ControlLogix™ Controller Revision 10

Cat. No. 1756-L55, -L55M12, -L55M13, -L55M14, -L55M16, -L55M22, -L55M23, -L55M24

Publication 1756-RN597A-EN-E - December 2002

Removal of the MGPS Instruction

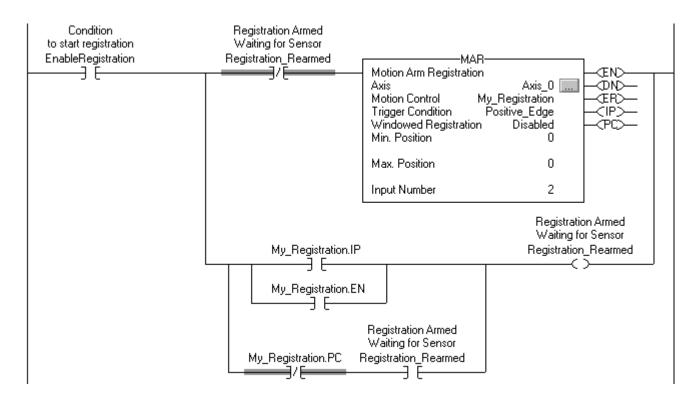
The MGPS instruction is no longer available. When you update your project to this revision, any MGPS instructions automatically convert to MGS instructions with the Stop Mode set to Programmed.
